# 2023/4899/P - 65 Regent's Park Road

Delegated Report (Members Briefing)		port	Analysis sheet		Expiry Date:	11/01/2024			
		ing) <sub>n/a</sub>		,	Consultation Expiry Date:	04/02/2024			
Officer				Application Number					
Tony Young				2023/4899/P					
Application Address				Drawing Numbers					
65 Regent's Park Road London NW1 8XD				Refer to draft decision notice					
PO 3/4	Area Tea	m Signature	C&UD	Authorised Officer Signature					
Proposal									
Shopfront alterations at ground floor level, including installation of replacement glazing.									
Recommendation Grant I taken			anning Permission and Warning of Enforcement Action to be						
Application Type		Full Planning Permission

Shopfront alterations at ground floor level, including installation of replacement glazing.

Image 5 – **proposed** shopfront (drawing A102.00 extract)

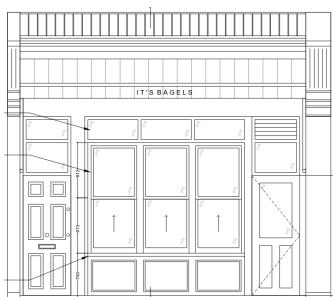
1. 'We object to the current shopfront which goes against the guidance on shopfronts in the Primrose Hill Conservation Area Statement (current SPD for the CA): PH44 at p. 34 refers to the need to respect 'the proportions, rhythm and form of the original frontages'. While we do not object in principle to the use of timber vertical sliding sash windows, which are characteristic of traditional shop fronts in the CA, we object to the current application proposal on the basis that we do not think that the vertical mullions can be as narrow as shown.

We would want to see details at appropriate large scale showing how the sash mechanism would be incorporated into the vertical mullions. Given that the width of the mullions is critical to 'the proportions, rhythm and form of the original frontages' these details should be provided before the application is determined, and not reserved by condition.

We also object to the tripartite division which does not respect 'the proportions, rhythm and form of the original frontages'. We would be happy to review revisions, and further information as requested.'

- 3.5 Whilst the proposal would sub-divide the central glazing of the pre-existing shopfront, the use of timber vertical sliding sash windows (see Image 5 below) is noted as being a characteristic of traditional shopfronts in the Primrose Hill Conservation Area and more generally for Victorian shopfronts.

1. The use of timber frame, vertical sliding sash windows are noted as being characteristic of traditional shopfronts within the conservation area and the tripartite sub-division of the proposed windows would be in keeping with the appearance of several existing ground floor frontages along Regents Park Road itself (see Sections 2-3 below for full assessment). During the course of the application, the applicant provided additional drawings which included the detailed configuration and size of vertical mullions and sash mechanism. These were made available to view on the Council's website. At the request of the Primrose Hill CAAC, the determination of the application was delayed so that the information could be reviewed and further comments made if necessary. The Council has not received any further response from the CAAC (or indeed any other interested parties).

- 3.7 The submitted drawings, therefore, indicate that the proposed tripartite division of glazing by vertical sash windows, including top-lights above and a reduced height stallriser below, would appear in keeping with existing shopfronts within the wider streetscene and would respect the proportions, rhythm and form of original frontages, so preserving the visual character and appearance of the host frontage and wider Primrose Hill Conservation Area.
